Access Compliance Report Public Rights-of-Way (Curb Ramps)

Main Street: PROSPECT_AVE Cross Street: LEAFWOOD_LN Location: SW

ADA ID: RPAT211018151039 Ramp Type: Type 3 - Combination 1 Initial Pass/Fail: Fail Overall Compliance: No Severity Score: 5

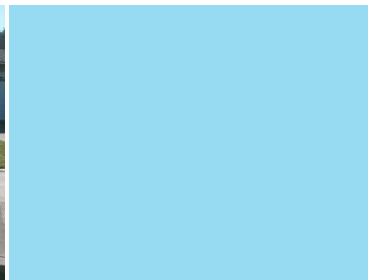
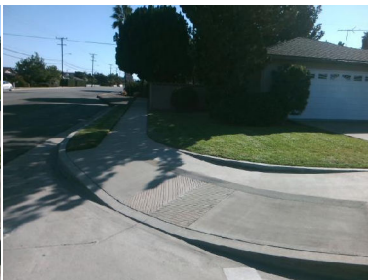
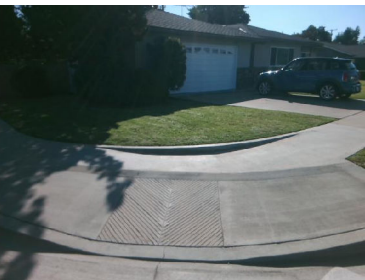
R304.2.2, R204.3, R304.5.1, R304.5.3, STD 1115

Remove & Replace Curb Ramp With Two New Directional Ramps or Equivalent. Remove & Replace Sidewalk.
